**AGENDA
CITY OF CEDAR FALLS, IOWA
PLANNING AND ZONING COMMISSION MEETING
WEDNESDAY, JUNE 24, 2020
5:30 PM AT CITY HALL**

TO: Planning & Zoning Commission
FROM: Shane Graham, Economic Development Coordinator
Matt Tolan, EI, Civil Engineer II
DATE: June 18, 2020
SUBJECT: Wild Horse Ridge Preliminary Plat Amendment

TO: Planning & Zoning Commission
FROM: Shane Graham, Economic Development Coordinator
DATE: June 17, 2020
SUBJECT: Highway-1 District Site Plan Review

TO: Planning and Zoning Commission
FROM: Karen Howard, AICP, Planning & Community Services Manager
DATE: June 18, 2020
SUBJECT: MU District Site Plan for Immanuel Evangelical Lutheran Church parking lot expansion (Case #SP20-006)

PRELIMINARY PLAT

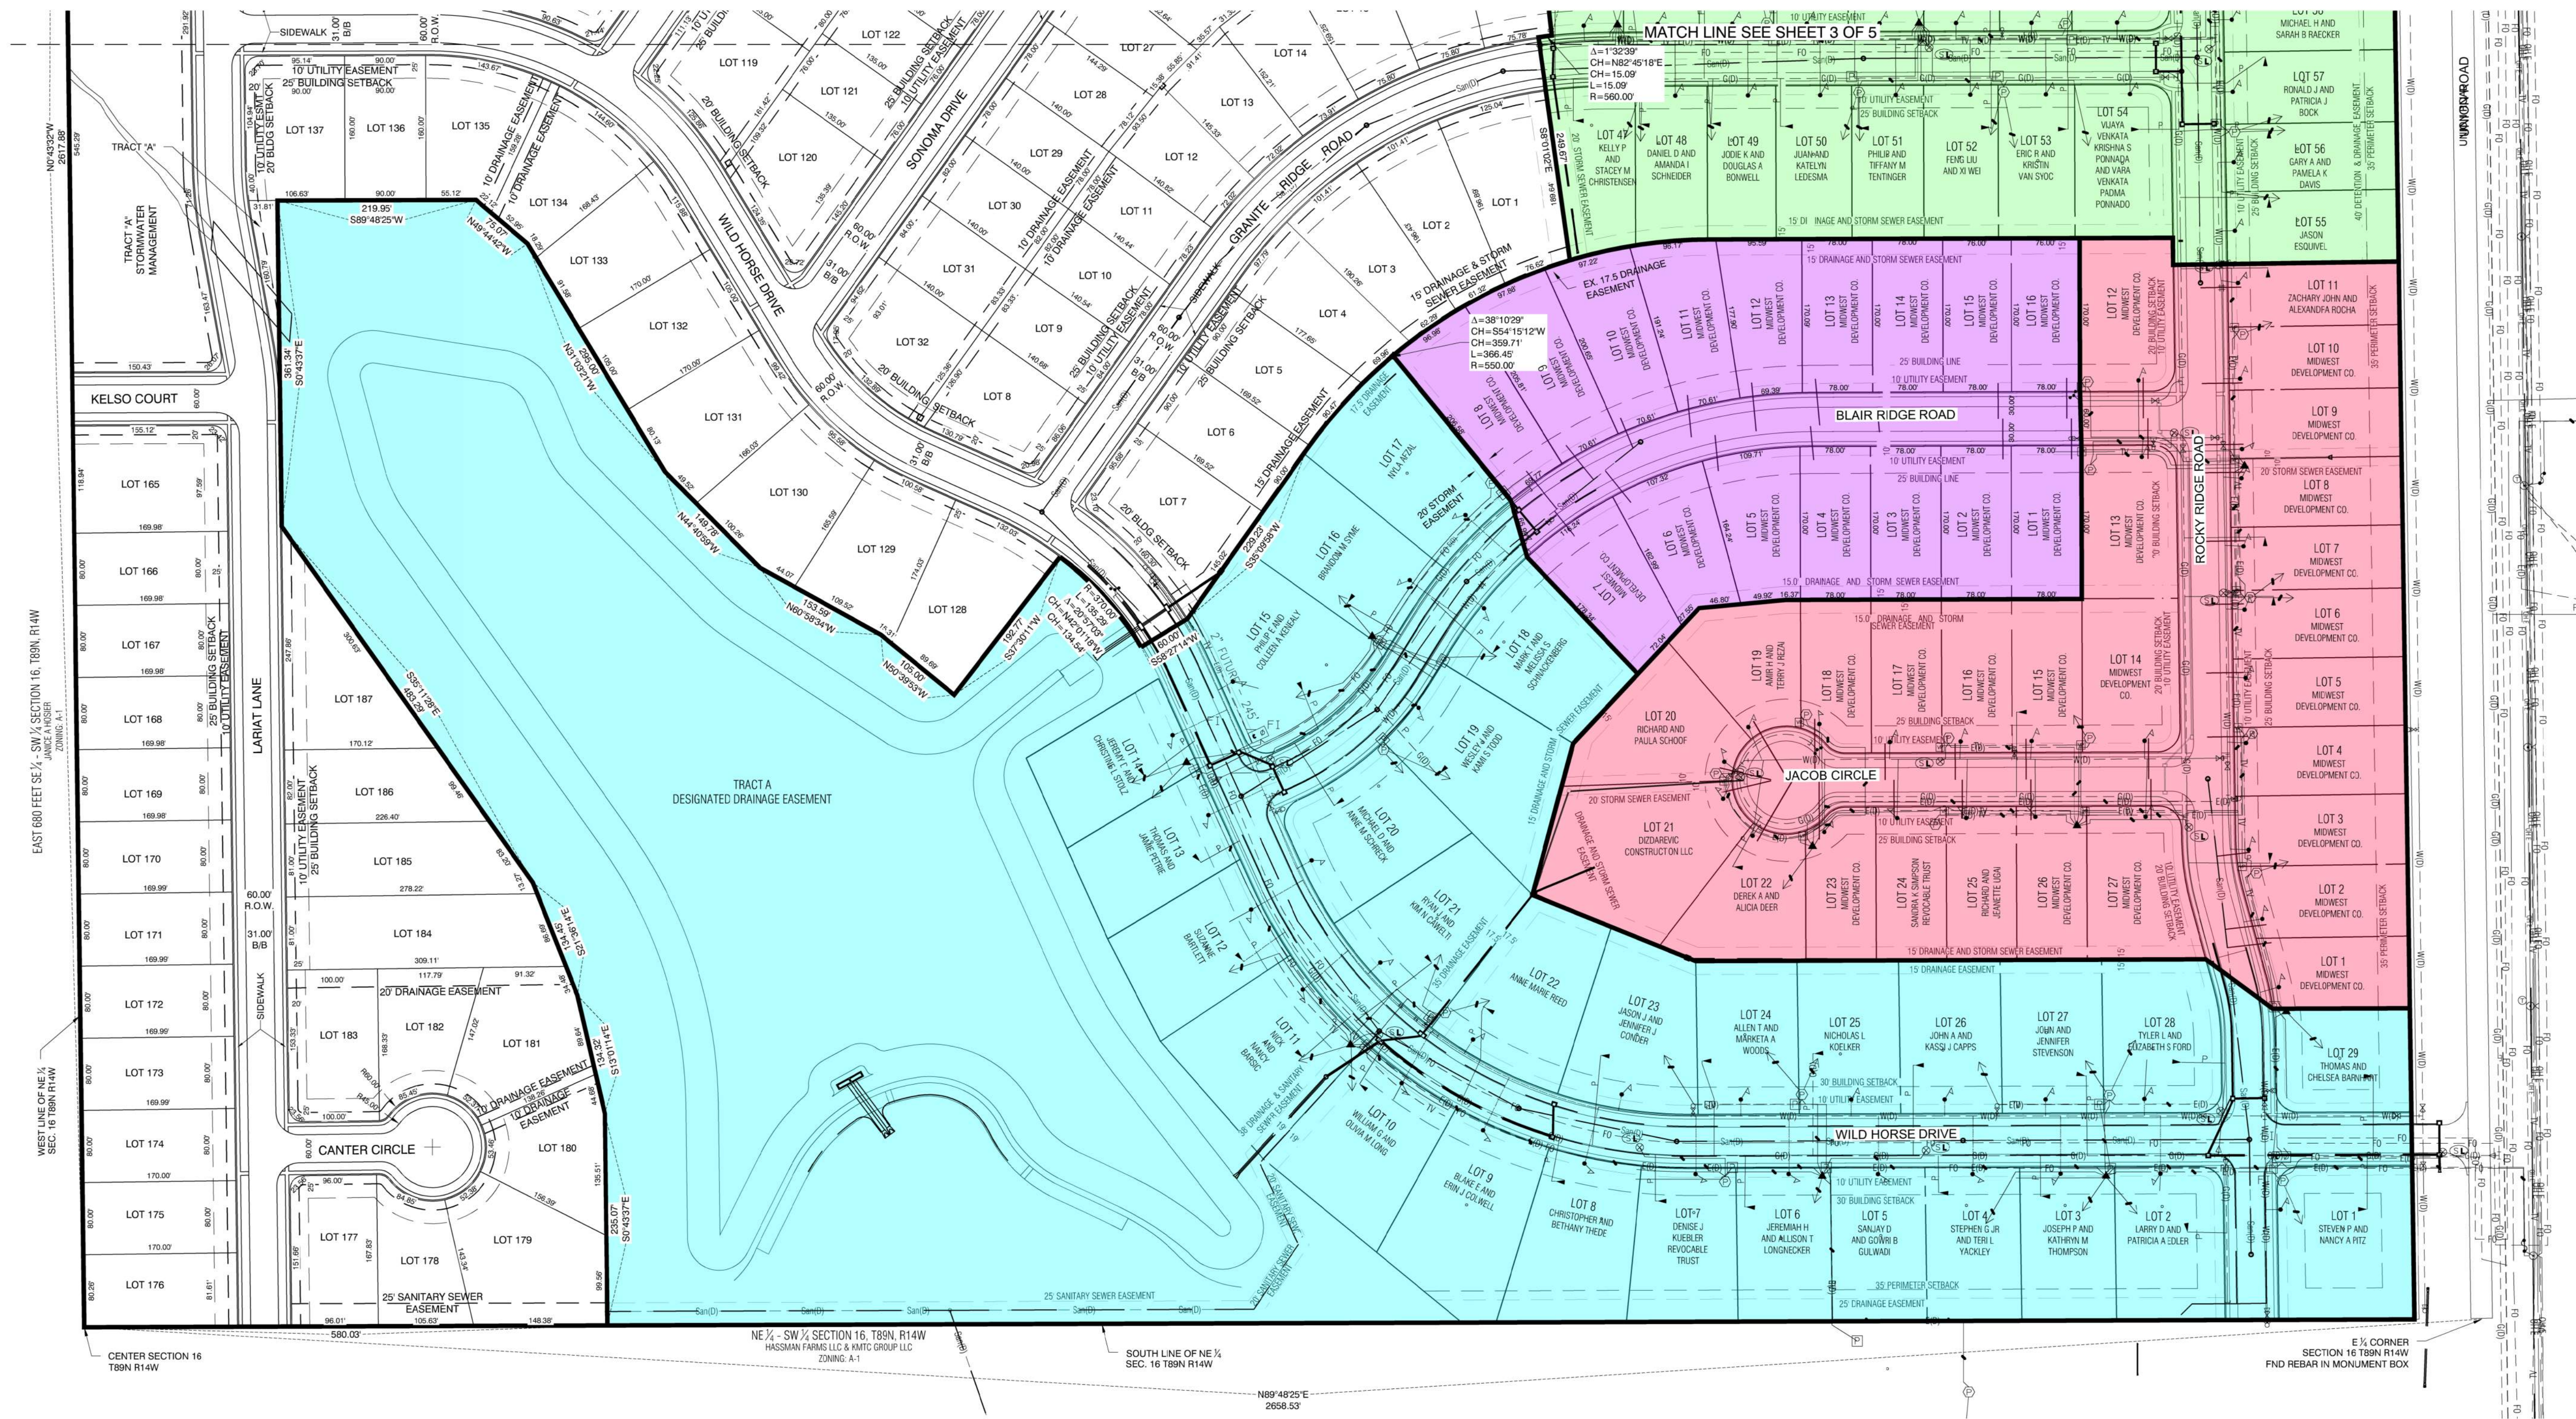
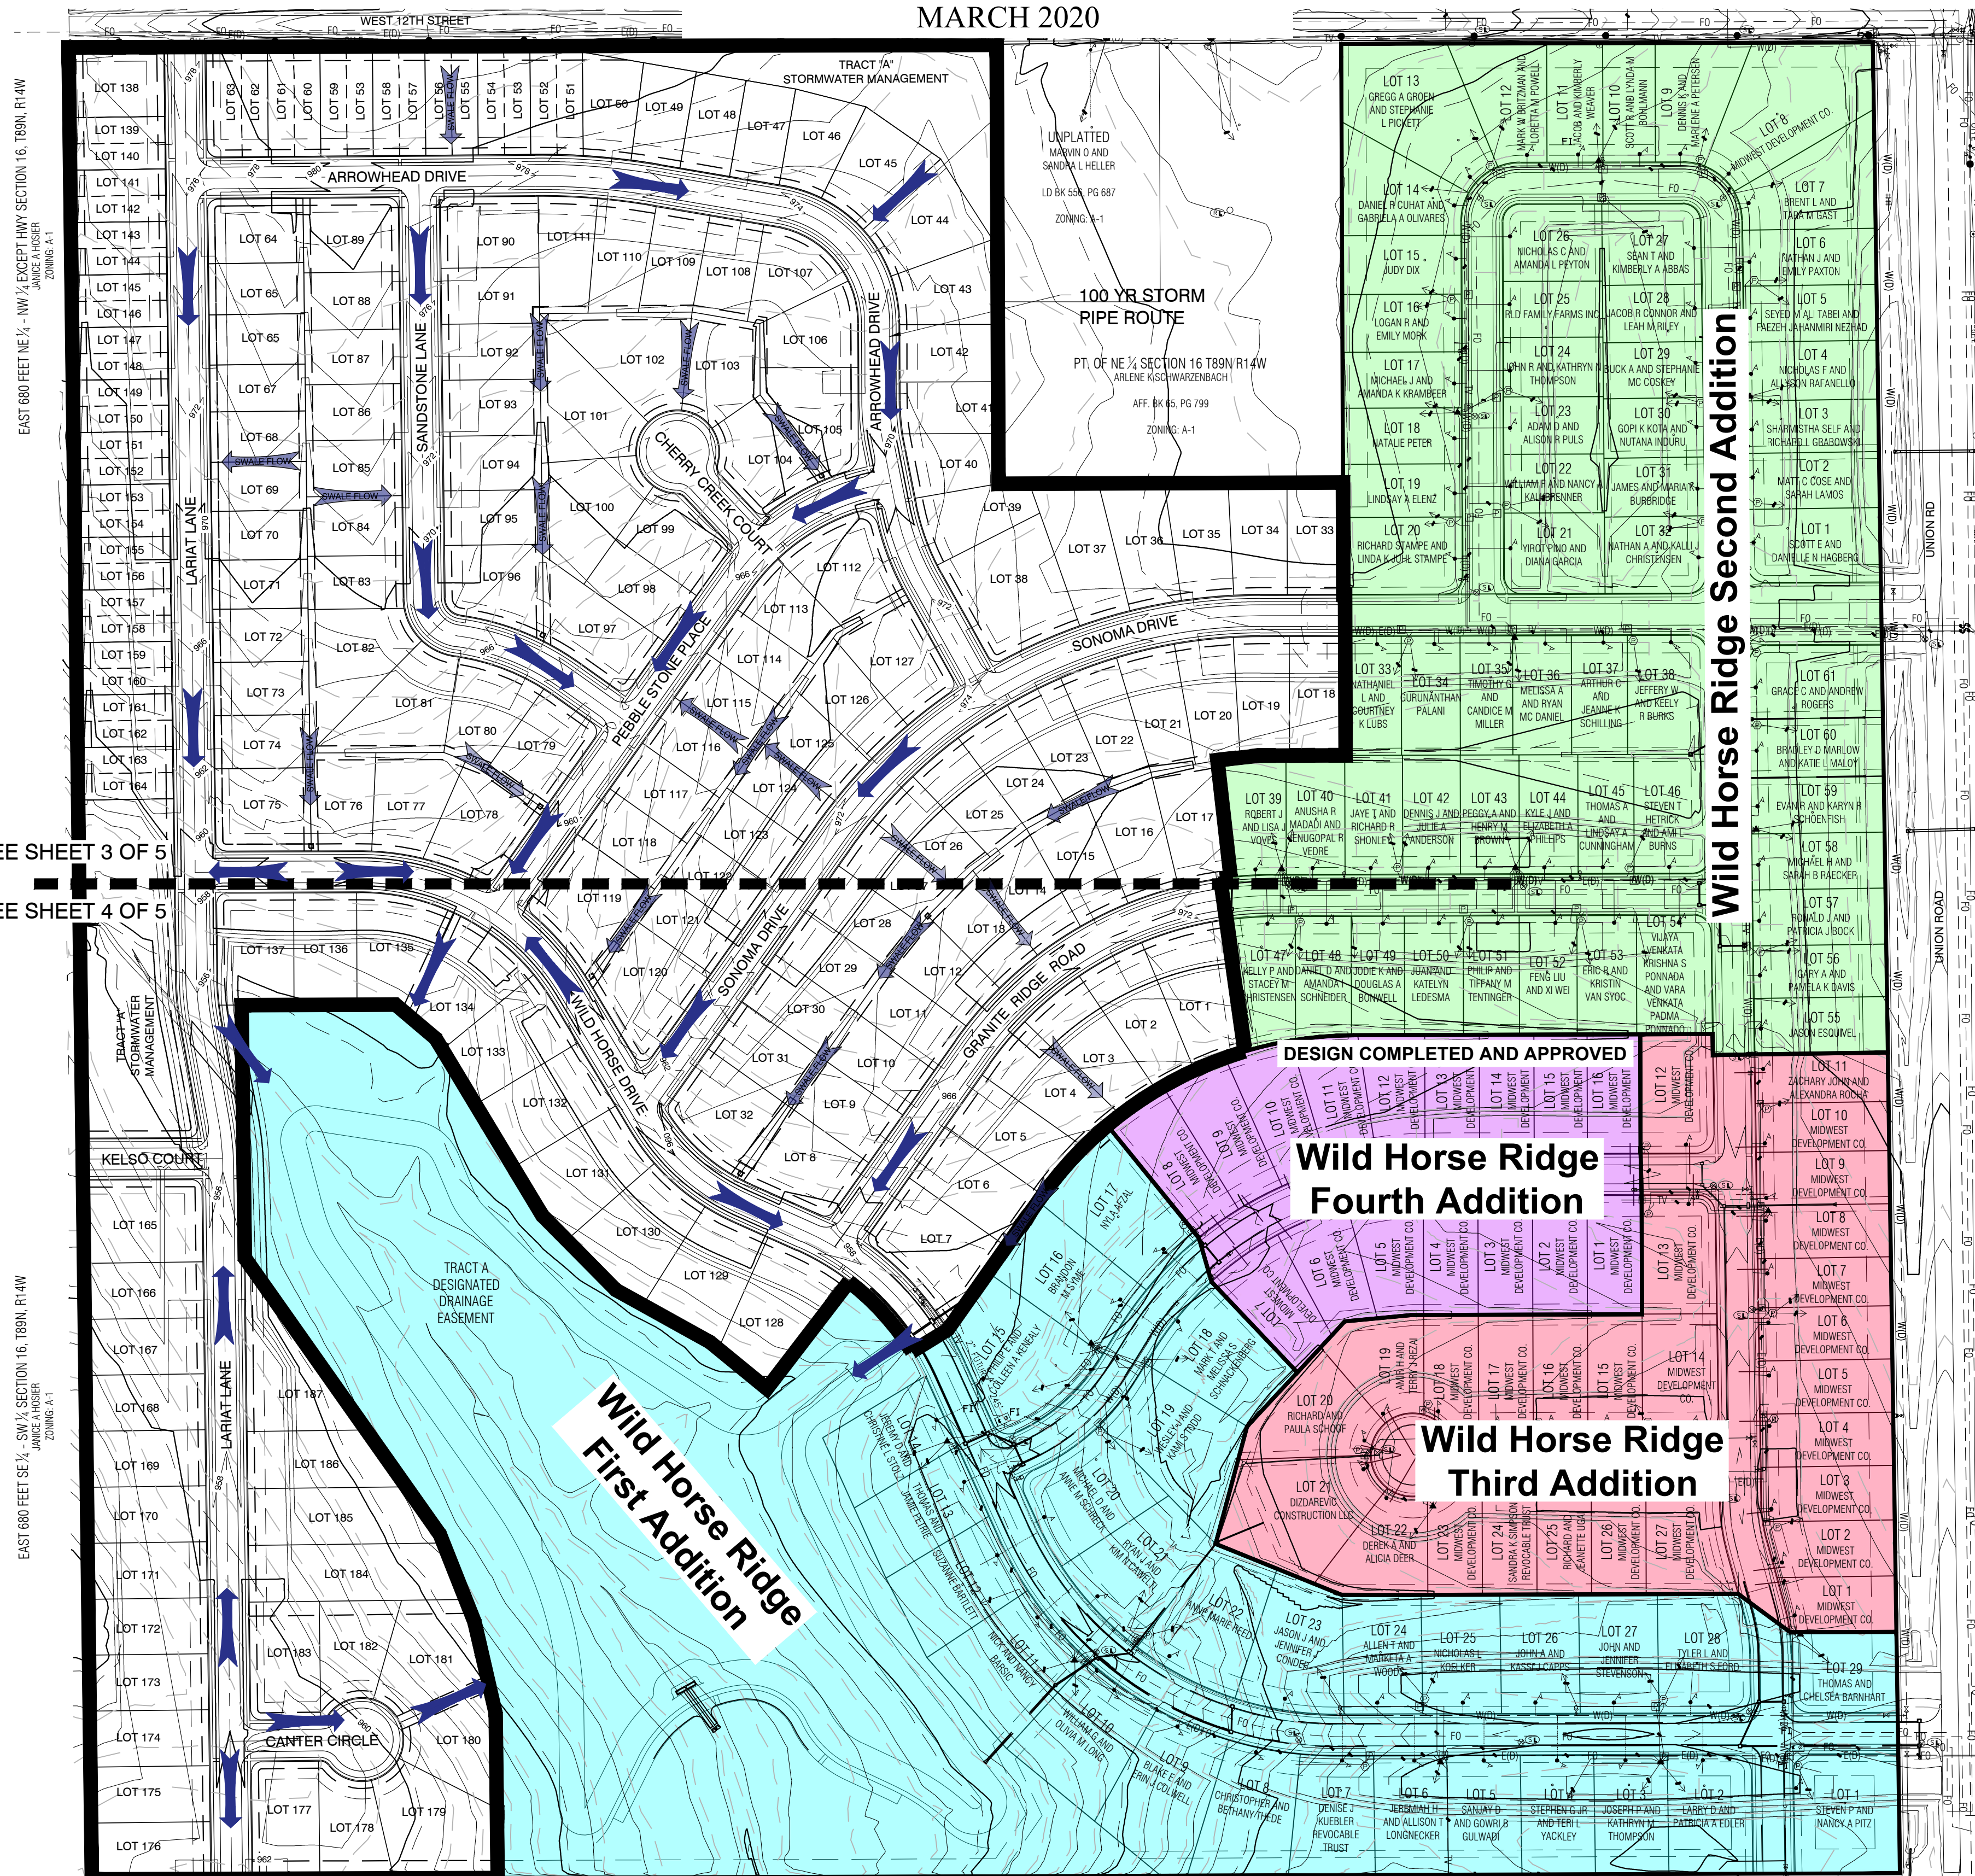
The developer has requested a change in the number of lots that were originally approved in the preliminary plat. They intend to construct a number of duplex units along the western and northern edge of the subdivision. The following table shows the proposed number of lots in the final five phases of this subdivision, and which addition the duplex lots will be located.

Along with this density change several new street layouts are being proposed. The original preliminary plat showed a cul-de-sac (Tyler Drive) located near the northwest corner of the plat. That is being removed, and Sandstone Lane will now be a through street that connects Arrowhead Drive to Pebble Stone Place. A smaller cul-de-sac, Cherry Creek Court, will be located just to the east of Sandstone Lane and will serve 6 lots. Also, Arrowhead Drive, which originally connected to W. 12th Street, now curves and connects with Lariat Lane, which does connect with W. 12th Street. Staff has worked with the developer to determine that two accesses from the subdivision to W. 12th Street is not needed. In addition, Granite Ridge Road, shown in the Fifth Addition, originally showed a small circle drive within the road, but this has been

The introduction of this amended preliminary plat is for discussion and public comment purposes. If the P&Z Commission is comfortable with the submitted preliminary plat, it is their decision on whether to forward for additional P&Z Commission review on 7/8 or to approve the amended preliminary plat on 6/24. The Community Development Department has reviewed this amended preliminary plat and would recommend approval.

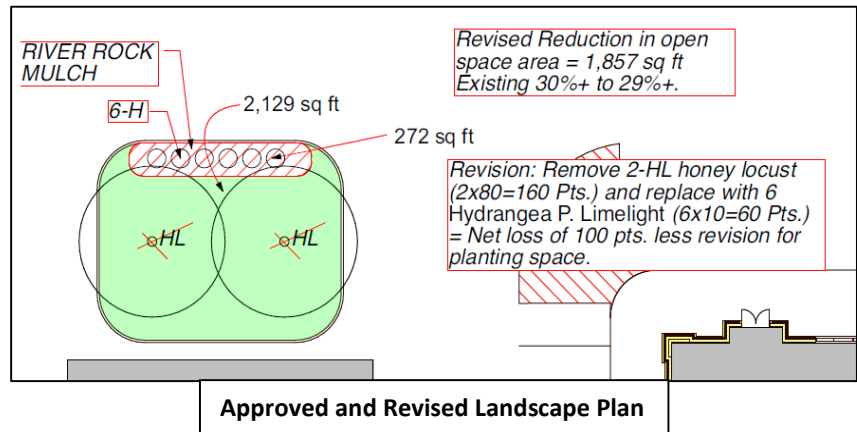
- 2) Parking/Access: The number of parking spaces for the convenience store/auto service center is not being altered. On the original approved site plan, there was shown a 53'7" wide by 36'6" deep (1,857 sf) landscape island located to the north of the fuel dispenser canopy and south of the main access drive, which served as not only a landscape area, but an area that separated the main access drive on the property and to the restaurant to the west. The current proposal by the developer is to reduce this

Such a large reduction in the size of this island would have a negative impact on safety by not having a well-defined main access and drive aisles on the site. Staff notes that the vehicular drive between the fuel canopy and the parking is already excessively wide. This paved area is 39.3 feet wide to the west of the canopy and 32 feet wide to the east of the canopy, and with the reduction to the island would be even wider at 52.8 feet and 45.5 feet, respectively. To provide a comparison, a typical parking aisle is 24 feet wide. A two-way street in Cedar Falls is 31' feet wide. Further increasing the paved area to such a significant degree, with 46 feet between the proposed island and the fuel pumps, will result in undefined and unpredictable traffic movements between the parking aisle, the circulation drive and the area near the fuel pump. In addition, the applicant intends to encourage use of this area for parking of large vehicles, such as buses and trucks, which will introduce additional conflicts between parked vehicles and drivers trying to access the fuel pumps.

Staff is concerned about the reduction in size of the landscape island as it relates to safe vehicular movement and access on the site, and therefore recommends against allowing such a substantial reduction in the size of the island.

Staff discussed with the applicant a smaller reduction in the size of the island to create easier two-way movement next to the northernmost fuel pump and indicated that this type of minor change could be approved administratively. A 10-foot reduction in the depth of the island would provide for two-way traffic movement next to the pump, but would maintain the substantial landscaped island and create a more defined traffic circulation.

The Community Development Department has reviewed the revised site plan and would recommend denial of the request as submitted, but would recommend approval of a revised site plan that shows a reduction of the island by only 10 feet, for a total reduced size of 53'7" wide by 26'6" deep, subject to the following stipulations:

Planting Plan Revision 22-2020

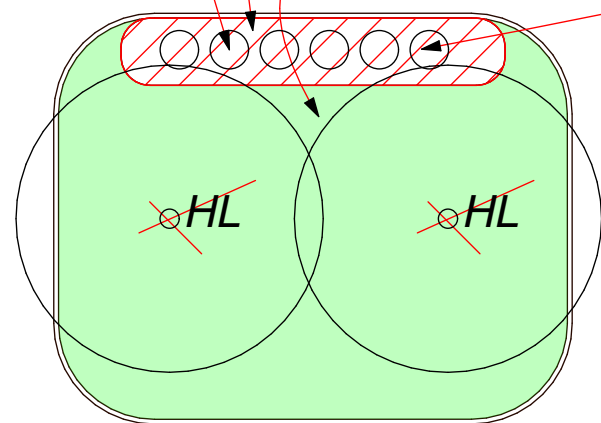
Revised Reduction in open space area = 1,857 sq ft Existing 30%+ to 29%+.

Revision: Remove 2-HL honey locust (2x80=160 Pts.) and replace with 6 Hydrangea P. Limelight (6x10=60 Pts.) = Net loss of 100 pts. less revision for planting space.

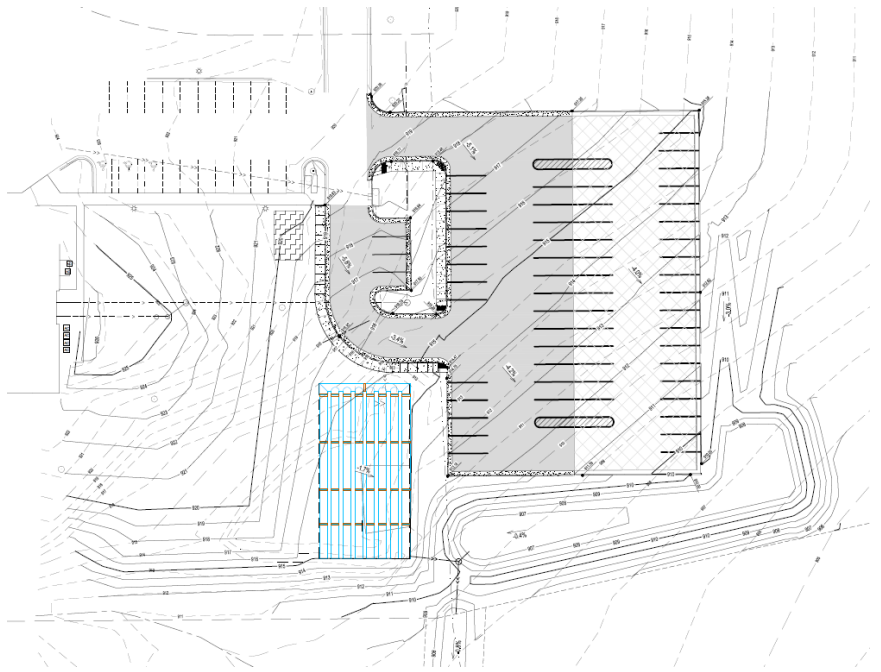
The general site landscaping requirement in the MU District is calculated at a ratio of 0.02 landscaping points per square foot of total development site area. For a 257,499 square foot site, 5150 landscaping points are required. The landscaping plan submitted with the proposed site plan (shown below and attached) consists entirely of trees, shrubs, and grasses planted around the perimeter of the proposed parking area. Subtracting the 4 trees required to satisfy the parking lot tree requirement, the proposed site plan includes trees and shrubs that equal 1030 points. The site plan indicates that the remainder of the new lot area will be seeded with grass or a wildflower seed mix. Landscaping installed with the original site plan for the church property satisfy 3100 of the required points. So 3100 points from the original site added to the 1030 points provided with the new site plan equals 4130 total points. The proposed site plan is 1020 points short of the MU District requirement (5150 – 4130 = 1020).

The zoning ordinance does provide discretion to the Planning & Zoning Commission to give credit for open green space on the site. It states, "If, in the judgement of the Planning and Zoning Commission the required number of points result in an excessive number of plantings, up to 10% of the total required points can be assigned to open green space at the rate of one point for each 500 square feet of open green space." So, based on the amount of open green space currently shown on the site, an additional 334 points could be granted toward the requirement, reducing the additional points required to 686. Staff discussed the shortfall with a representative for the church and with their engineering consultant, who prepared the

landscaping plan. They are agreeable to adding landscaping to meet the requirement and will prepare an amended landscaping plan to present to the Commission at the meeting on June 24. **Landscaping requirement is not met. Staff recommends additional trees and shrubs be added to the site plan to satisfy the additional 1020 points required (or as otherwise reduced by the Commission for credit granted for the open space) prior to City Council approval.**
